RE: MIP-16-04 at 2415 Dillow Street

TENTATIVE IMPROVEMENT PLAN
2415 Dillow Street Partition
T.2S., R.1E, Section 24, TL 7300-7400
City of West Linn, Oregon

2415 Dillow Street Partition Tentative Plan

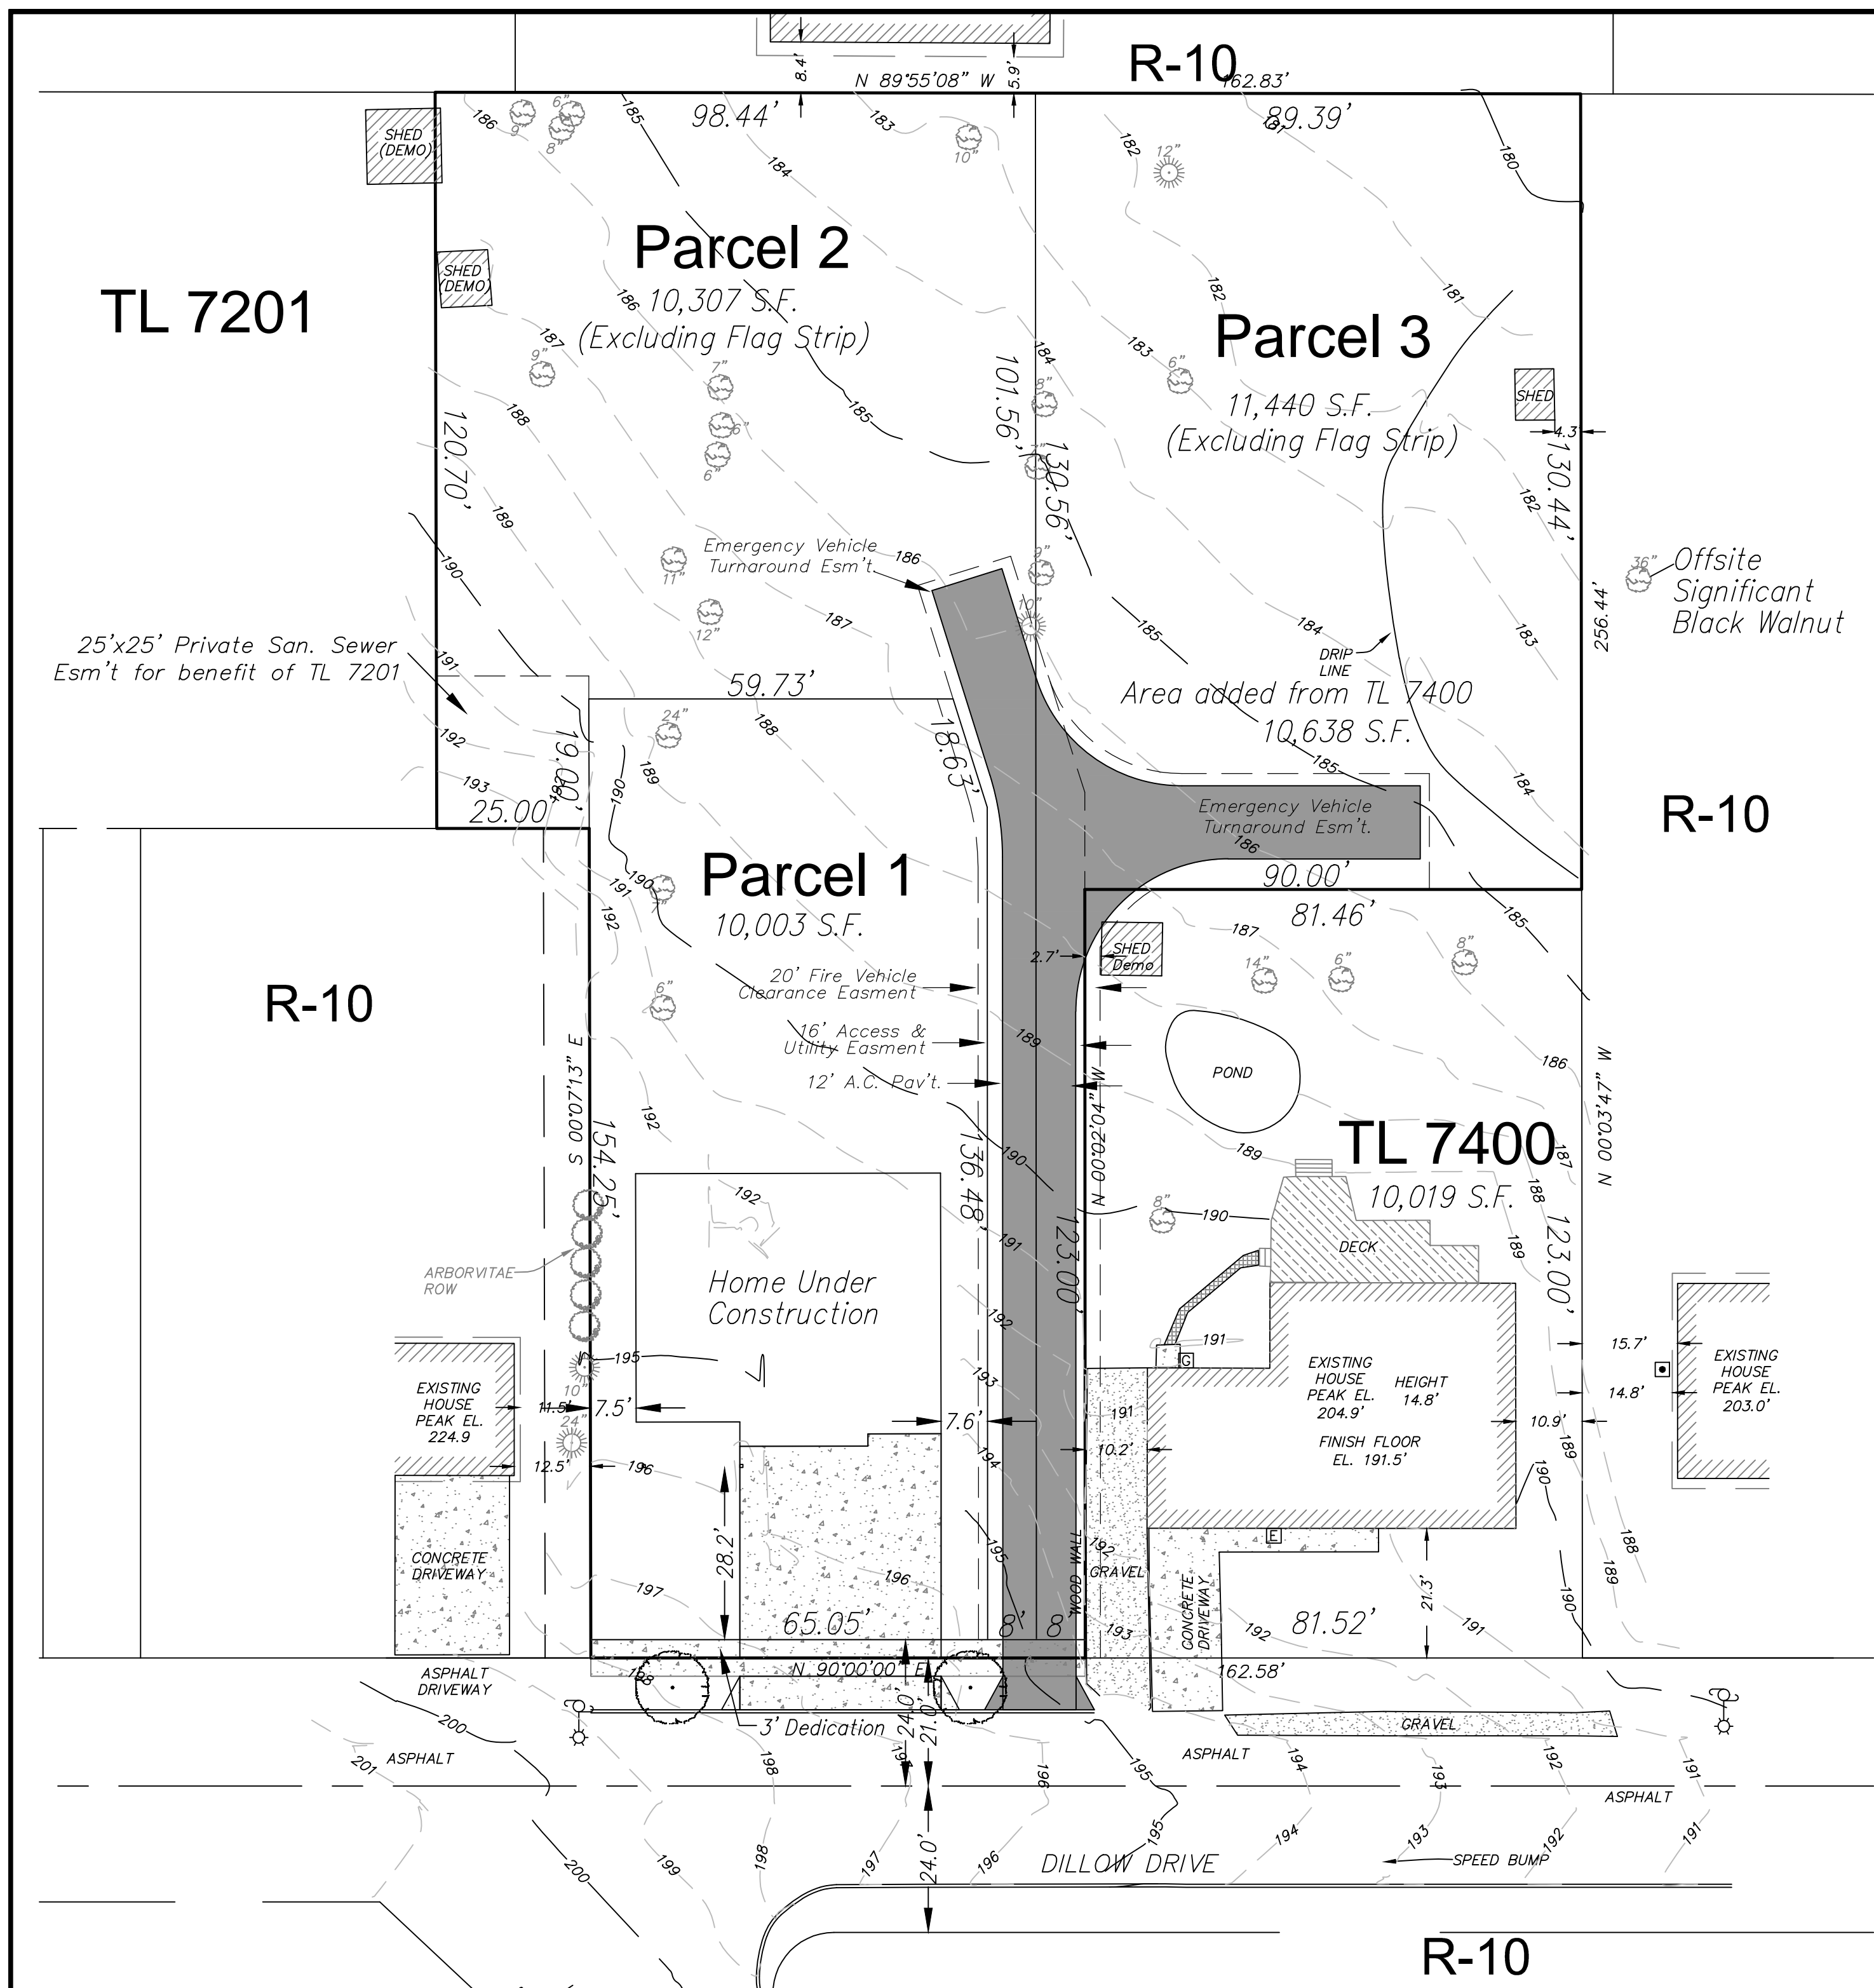
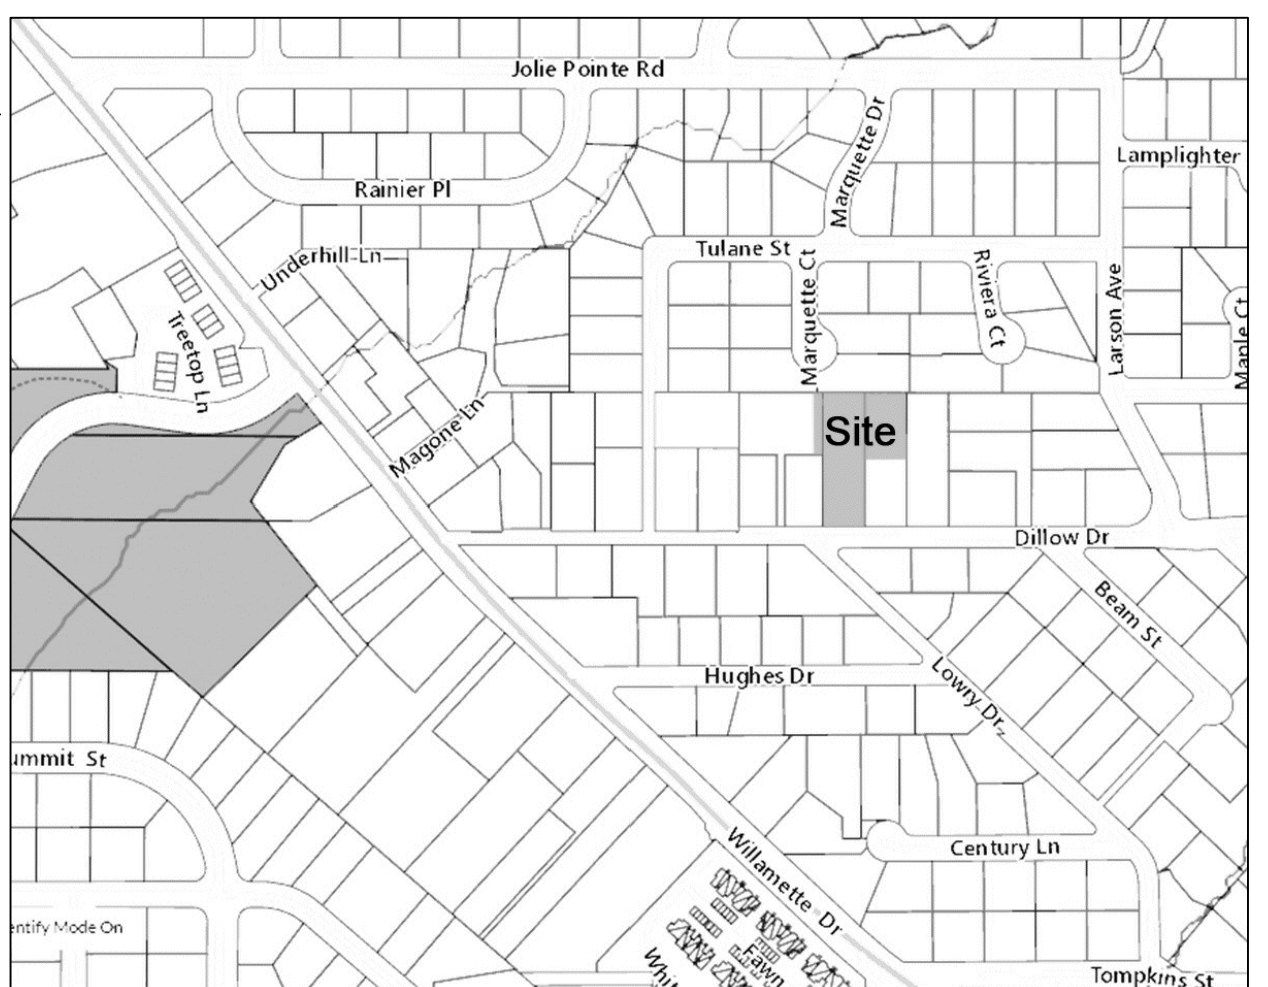
85.160 (E) (5) We retained Multnomah Tree Experts to tag the trees on the site. Mike Perkins subsequently visited the site and determined that there are no significant trees, tree clusters or heritage trees on the property. The Tentative Plan is noted accordingly. There is a large black walnut tree off-site to the east. We have depicted the location of the drip line of that tree on the Tentative Plan drawing. We will agree not to build within the depicted drip line on Parcel 3.

85.160 (F) (7) The Tentative Plan shows the location of two street trees to be planted along the frontage of Parcel 1. This plan was reviewed and approved by Mike Perkins.

85.170 (A) (7) A table showing density calculations for the maximum allowable number of lots is shown on the Tentative Plan.

85.170 (A) (8) All slopes on the subject property are less than 15% grade. This is noted on the Tentative Plan.

There are no significant trees at that address. The black walnut next door is however a significant tree and will need to be taken into account as far as protection of the roots.

So there will be a 50' section of sidewalk not connected to anything?

Are there sidewalk improvements? If not then I don't think we need street trees.

SLOPES: All slopes < 15% Grade

DENSITY CALCULATIONS:
Gross Site Area: 34,492 square feet.
Type I & II Lands: 0 square feet.
Access Easement: 2,287 sq. ft.
Net Site Area: 32,205 sq. ft.
Maximum Density @ 1 Unit Per 10,000 sq. ft. = 3 lots.
Three lots are proposed so both the minimum and maximum density standards are met.

Significant Trees: None on site per City Arborist.

DESIGNED: REG	3-2-2017	1	Added Slope and Density Calculation Information.
DRAWN: REG			
SCALE: 1" = 30'			
DATE: December 2016			
FILE: 15-ICN-102	DATE	NO.	REVISION

Yes, there will be a 6' sidewalk with a 5.5' planter strip between curb and sidewalk.
